CD-2023-264

**Subject: Federal Cell Facility Application: Responses to the Director's Request for Information –
DRC-2023-078530**

Appendix B: Federal I Cell Facility Engineering Drawings

"CLIVE" FACILITY
ENERGYSOLUTIONS SITE FACILITIES
RADIOLOGICALLY CONTROLLED AREA
CLIVE, UTAH

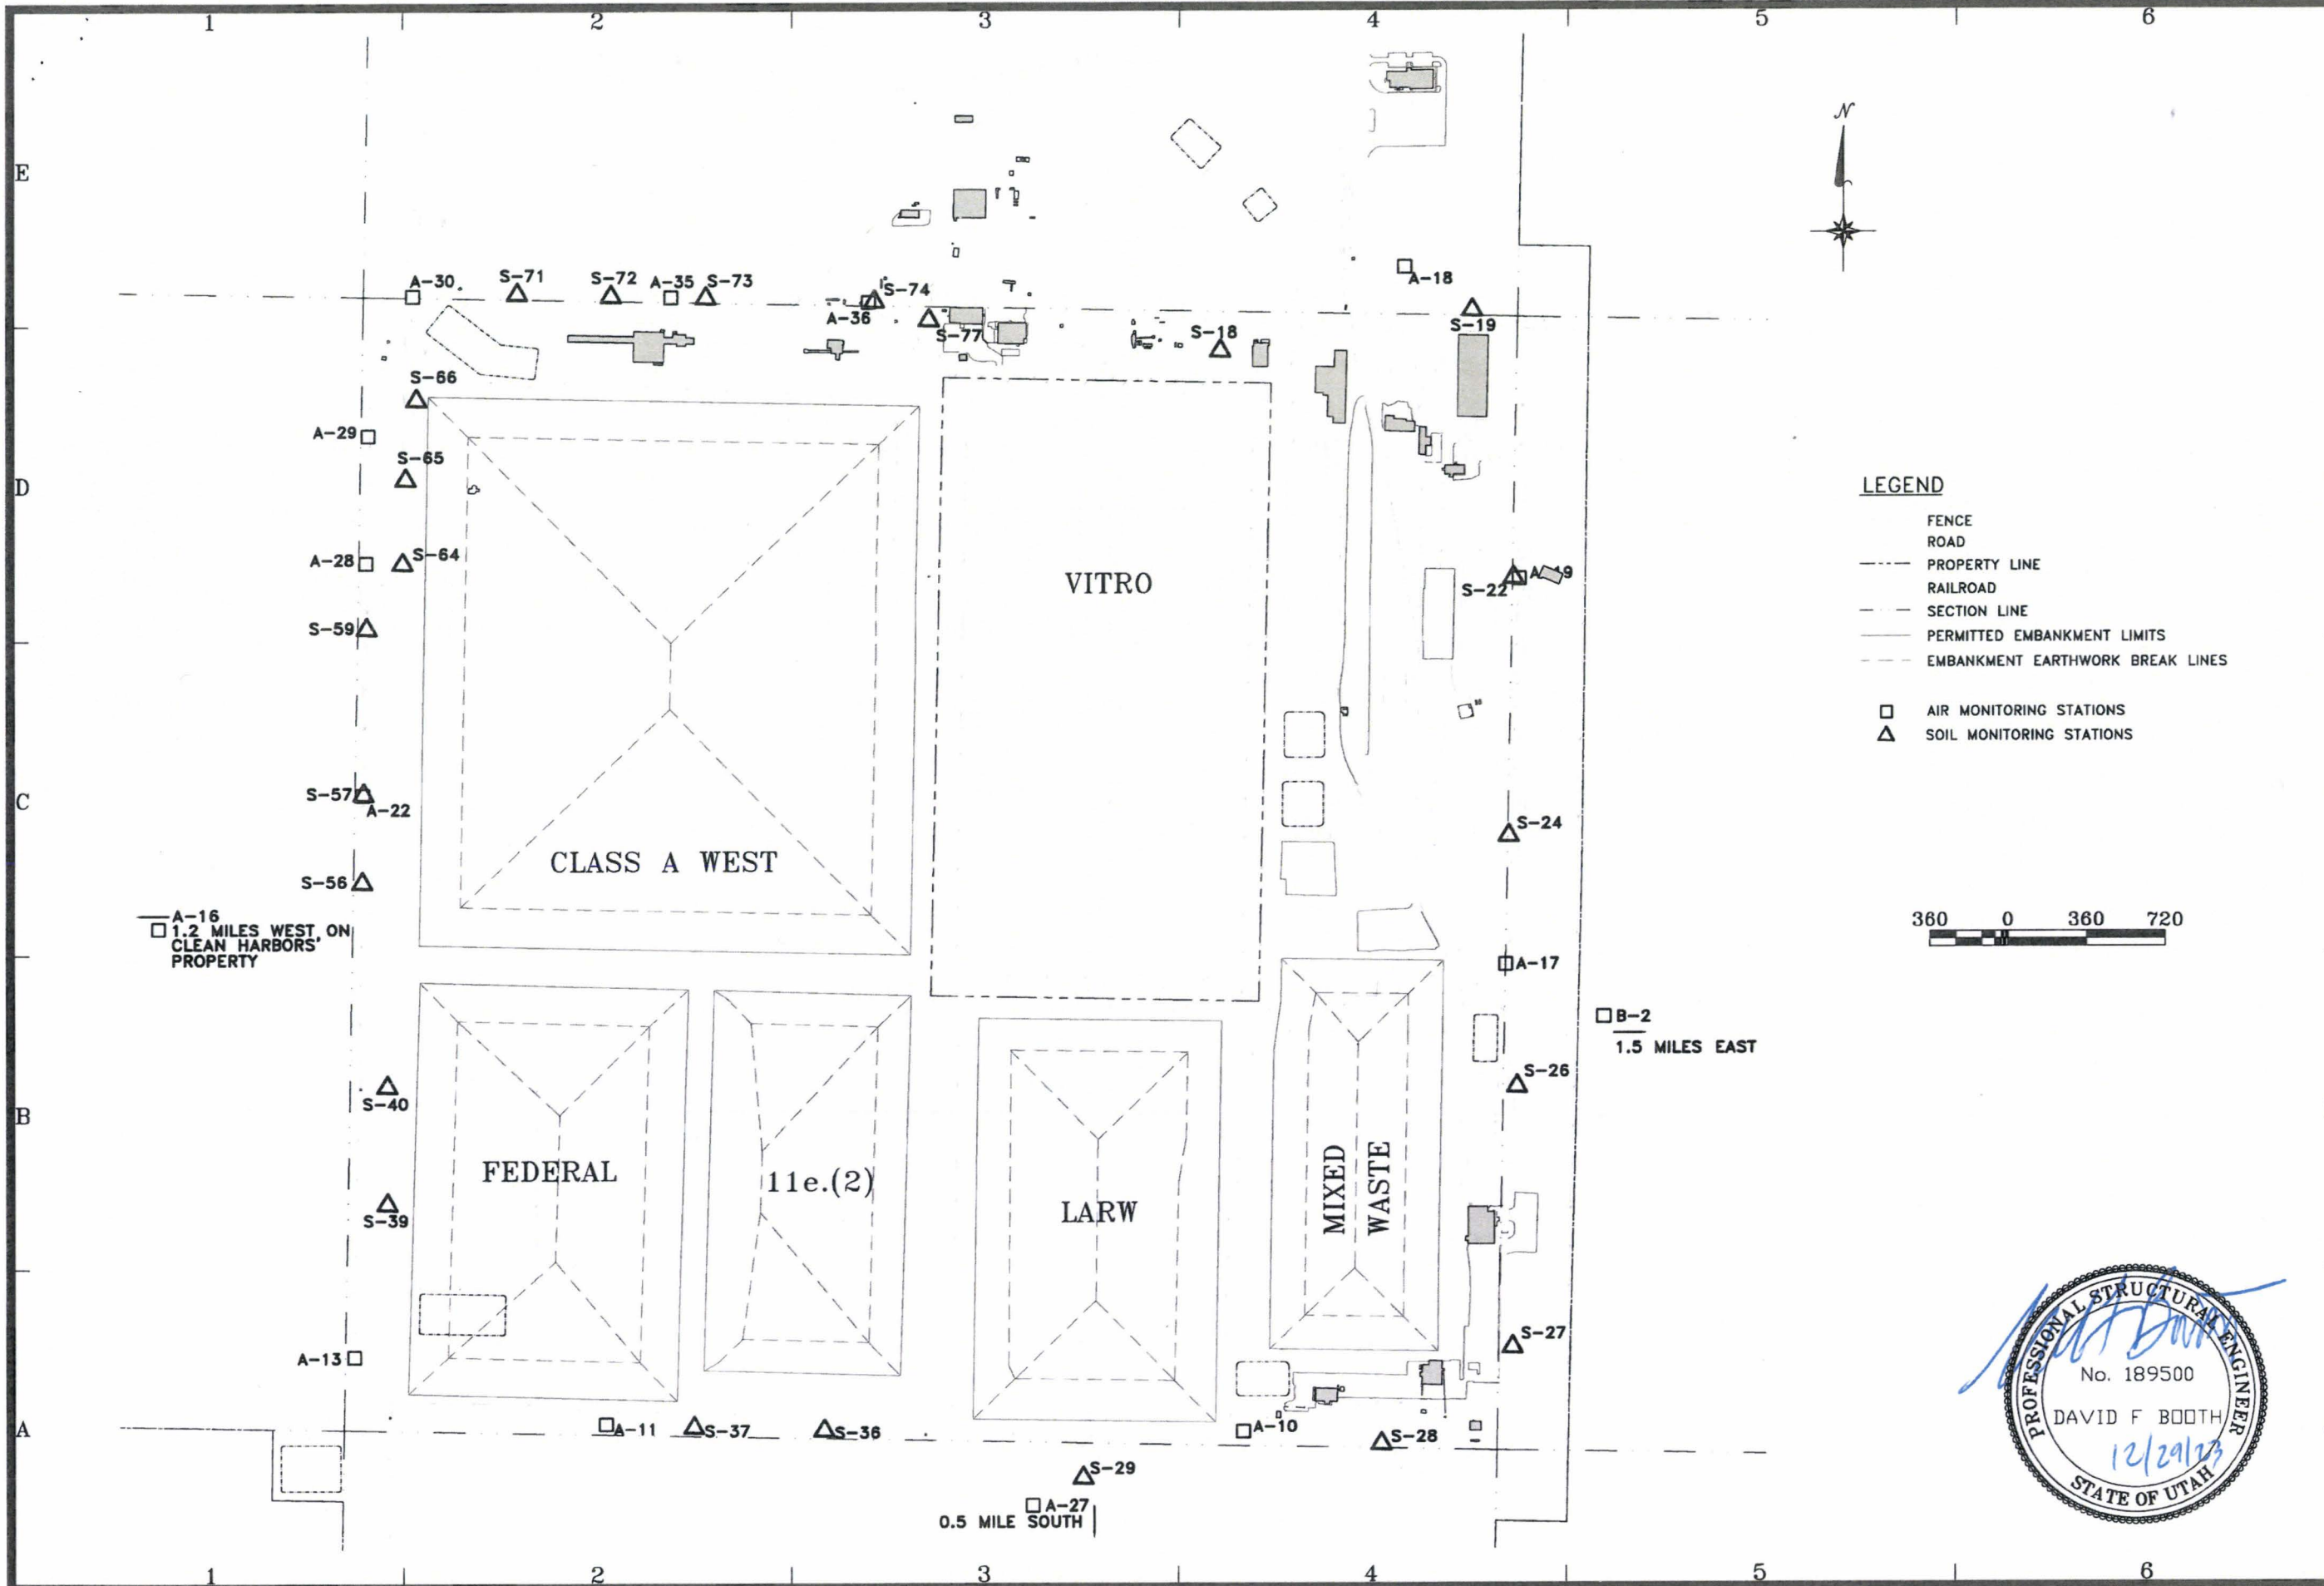
B-3: The drawing exhibits the 11e.(2) embankment design layout as one monolithic embankment. Please revise sheet to accurately depict the proposed embankment layout.

The 11e.(2) embankment and proposed Federal Cell Facility layouts have been adjusted in Engineering Drawings 0801-G04, 07007-J01, 07007-J02, and 07007-J03 to reflect the smaller footprint authorized by the 2022 amendment 3 to Radioactive Material License UT2300478.

DESIGNED BY	D. BOOTH
DRAWN BY	N. CLARKE
CHECKED BY	D. BOOTH
SCALE	AS SHOWN
DATE	05/22/07
PROJECT NO.	07007 J01

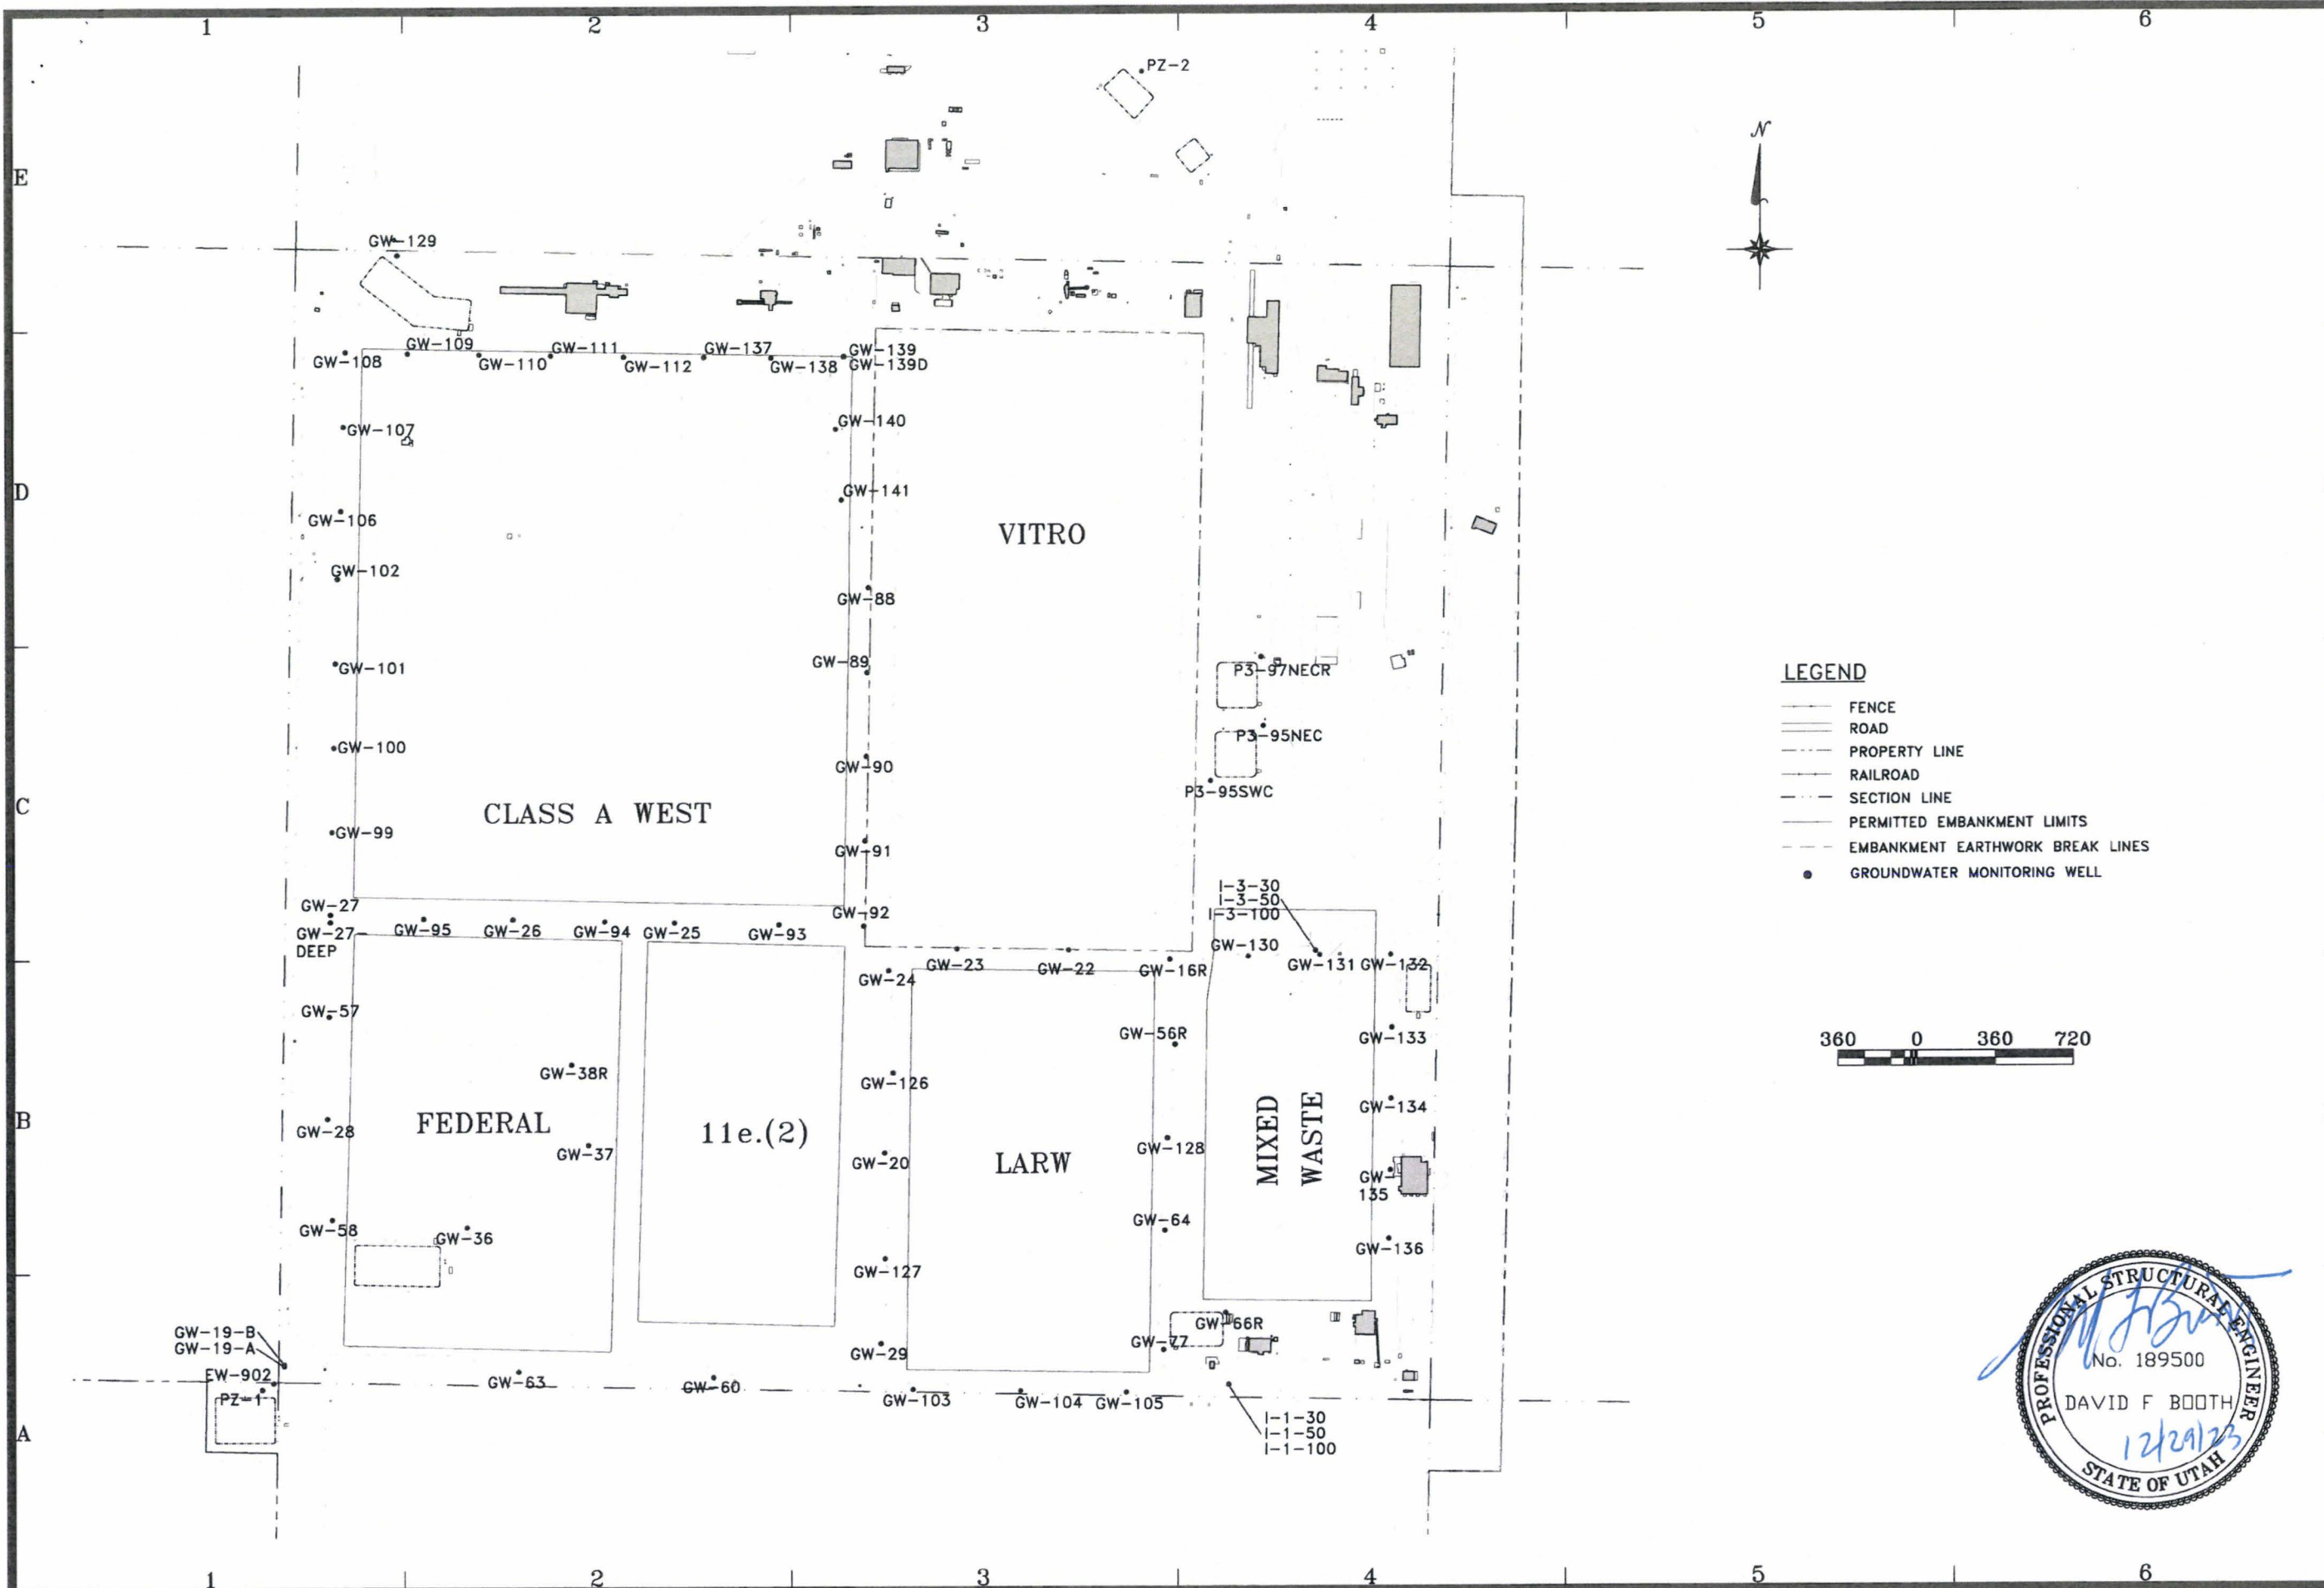
B-4: There is a lack of detail with the existing instrumentation in both the text and in the plans. Model, functionality, installation date, location (coordinates), minimum instrumentation parameters, etc. should be abundantly clear to the reader. A summary of instrumentation should be provided within the text or the plans for clarity. Please provide a summary that elaborates on these instruments' specifics, including notes on relative drawings.

The descriptions on Engineering Drawing 07007-J01 have been expanded to clarify the arrangement of the air monitoring array and monitoring instrumentation currently in use. Low-volume atmospheric dust monitoring stations are used to evaluate the effectiveness of radiation safety measures applied during bulk waste management within the Class A West embankment authorized by Radioactive Material License UT2300249. Since no bulk DU will be managed at the Federal Cell Facility, current instrumentation and monitoring locations are appropriate to support the Federal Cell Facility.
